AEP-NRC-2018-22
10 CFR 50.4

Donald C. Cook Nuclear Plant Unit 2
Response to Request for Additional Information Regarding Supplemental Information Regarding the
Reactor Vessel Internals Aging Management Program

Response to Request for Additional Information Regarding Supplemental Information Regarding the Reactor Vessel Internals Aging Management Program

Figure 1 – Baffle-Former Assembly with Columns Labeled (looking down from above)

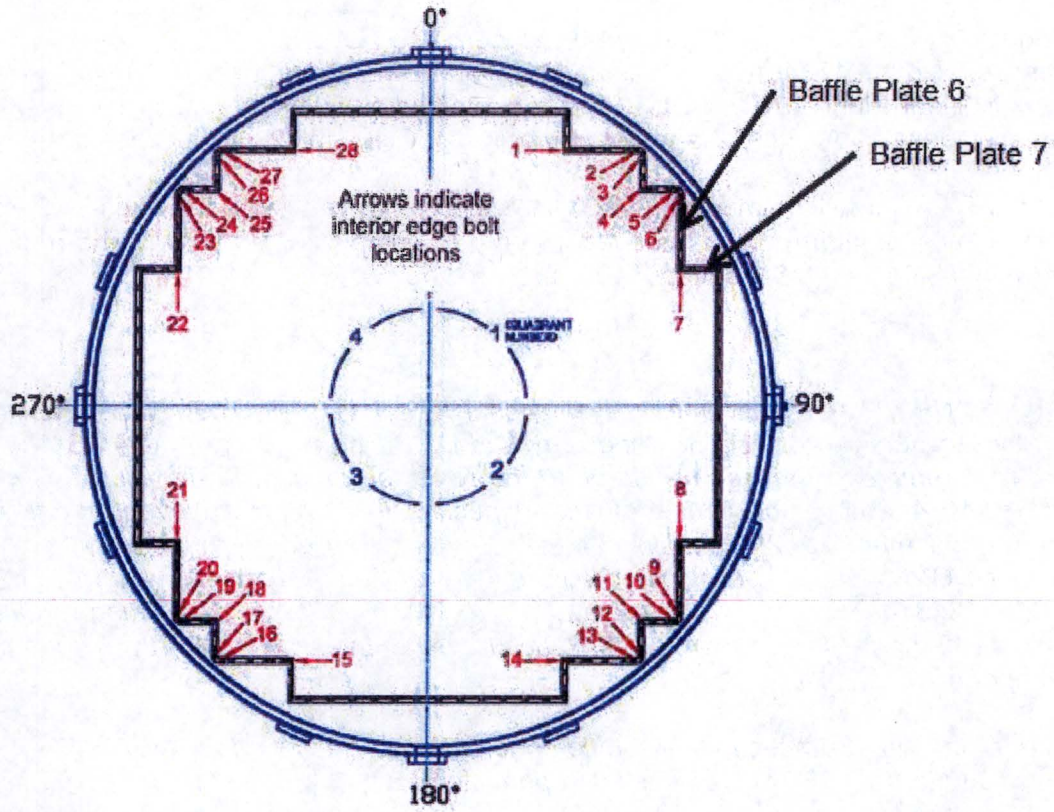
The NRC staff notes that the information provided in the December 8, 2017, submittal describes the process for baffle-edge bolt FMEA and the generic results of the FMEA, but does not take into account the specific "observed condition" of the baffle-edge bolts at CNP, Unit No. 2 as described in WCAP-17096-NP-A. Please provide the results of the baffle-edge bolt FMEA considering the as-found condition at CNP, Unit No. 2.

The plant-specific failure modes and effects analysis (FMEA) documented in WCAP-18131-P, Revision 1, "Background and Technical Basis Supporting Engineering Flaw Acceptance Criteria for D.C. Cook Unit 2 Reactor Vessel Internals MRP-227-A Primary and Expansion Components," was prepared prior to the baffle-edge bolt inspection and included a full range of potential conditions that could be observed. The observed condition of baffle-edge bolts at CNP Unit 2 was considered patterned/clustered which was an analyzed condition in the plant-specific FMEA documented in WCAP-18131-P. The condition was considered patterned/clustered since the five (5) baffle-edge bolts with relevant indications were located on the same column (Column 7 – see Figure 1) and were all between Former Level D and Former Level F (See Figure 2). Column 7 baffle-edge bolts fasten Plate 7 to Plate 6 as shown in Figure 1. The five baffle-edge bolts are locations Y, AB, AD, AE, and AF shown on Figure 2.
